HISTORIC LANDMARK COMMISSION
APRIL 27, 2020
APPLICATION FOR A CERTIFICATE OF APPROPRIATENESS
LHD-2020-0012
703 OAKLAND AVENUE
SMOOT/TERRACE PARK HISTORIC DISTRICT

Replace siding and windows, change the roof material, widen the front stoop, infill a second-story rear sleeping porch, demolish a rear garage, and add a below-grade basement.

COMMITTEE RECOMMENDATIONS

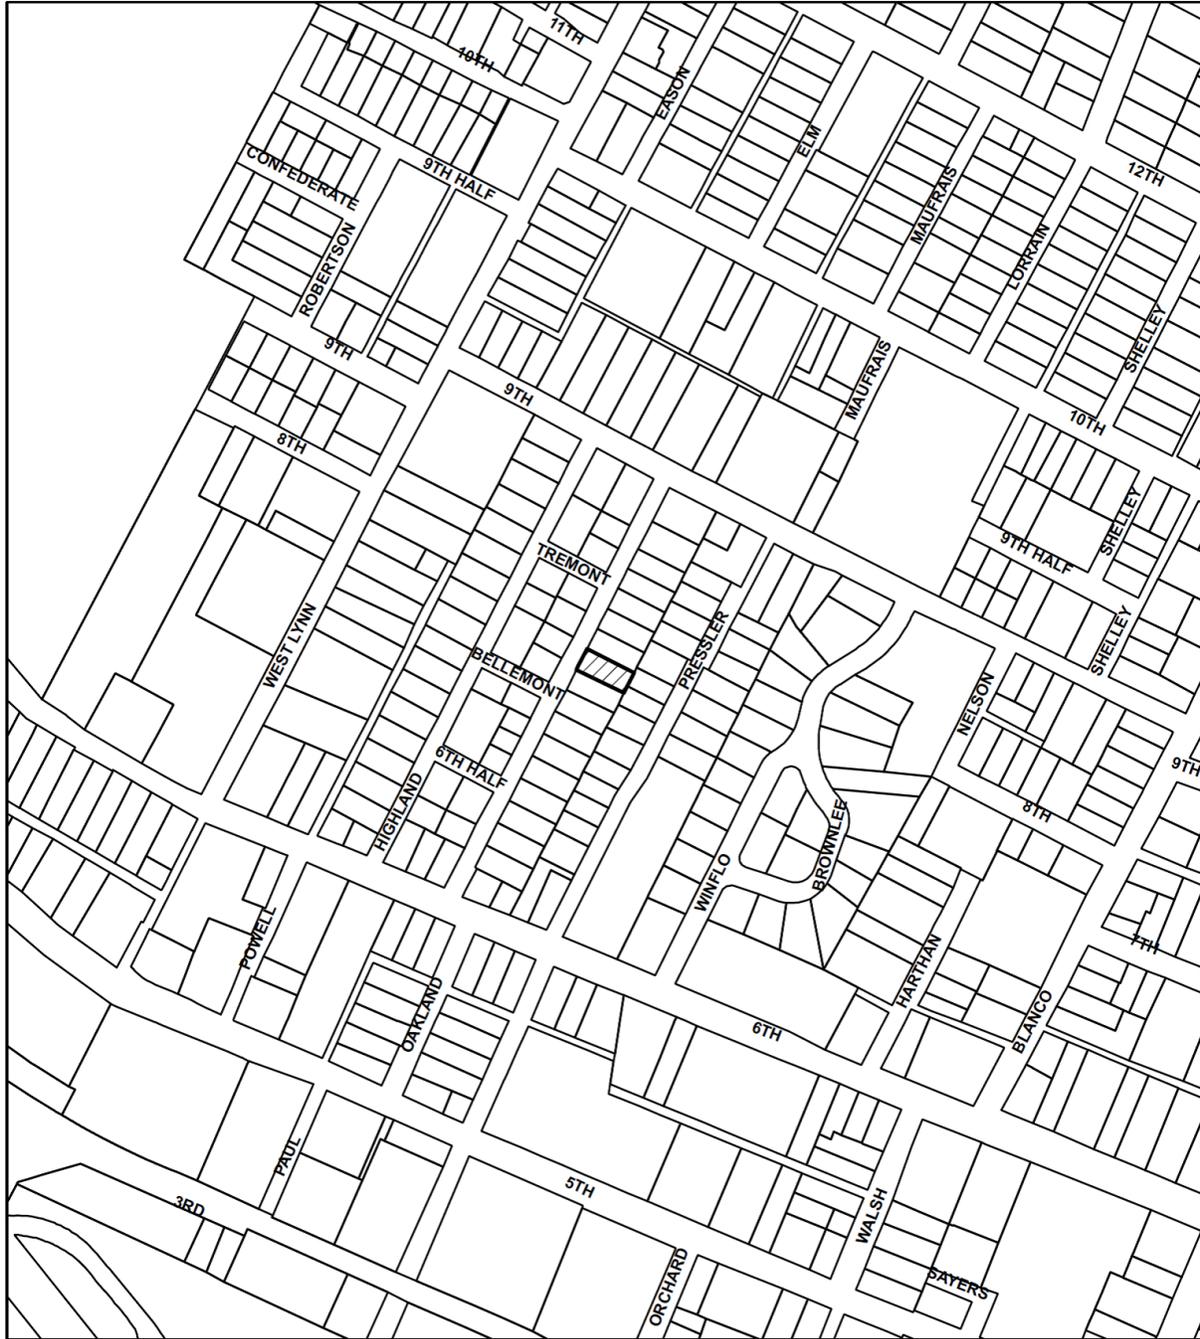
The committee noted that the replacement siding does not match the historic siding, but is typical of the neighborhood; and that replacement windows would have ideally matched the lite pattern of the historic windows. Committee members preferred to keep the shingle roof but acknowledged that the design standards allow a metal replacement roof.
